## Application for Works Approval Amendment

| <b>Works Approval Number</b> | W6919/2024/1  |
| <b>Works Approval Holder</b> | Covalent Lithium Pty Ltd  |
| <b>Premises</b>              | Earl Grey Lithium Project<br>Marvel Loch-Forrestania Road<br>MOUNT HOLLAND<br><br>Legal description –<br>Mining Tenement M77/1080<br><br>As defined by the Premises map in Schedule 1 of the Revised Works Approval |

Figure 1: Projection of evaporation system on EGGP water level.

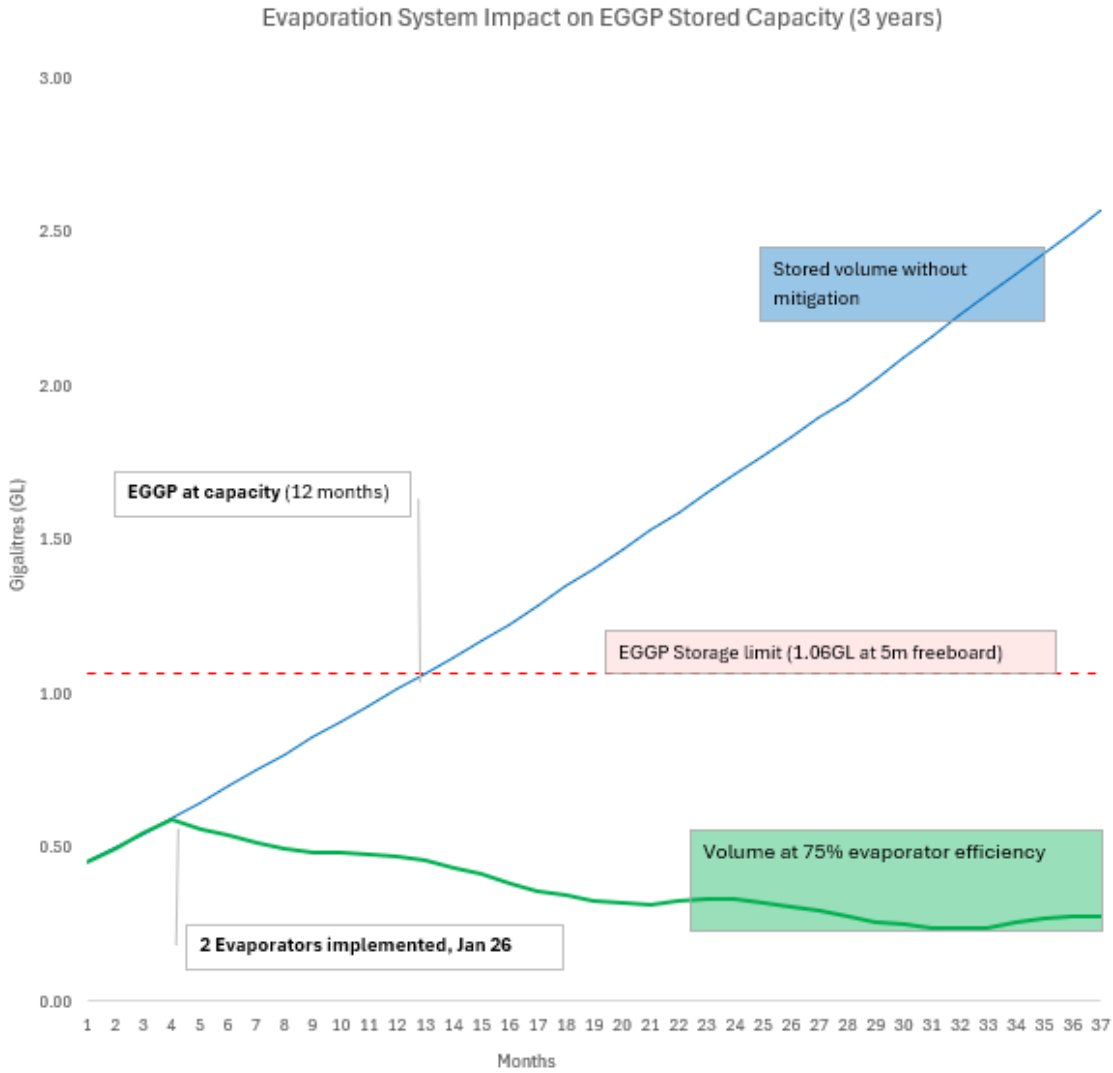
The water level in EGGP is rising in accordance with the abstracted volumes with some loss to permeability and evaporation. Figure 1 illustrates the projected fill rate to capacity of EGGP based on the current dewatering rates and illustrates the impact of mechanical evaporation on the EGGP water level, modelled from September 2025 for 36 months. Figure 1 indicates that EGGP will reach capacity in September 2026.
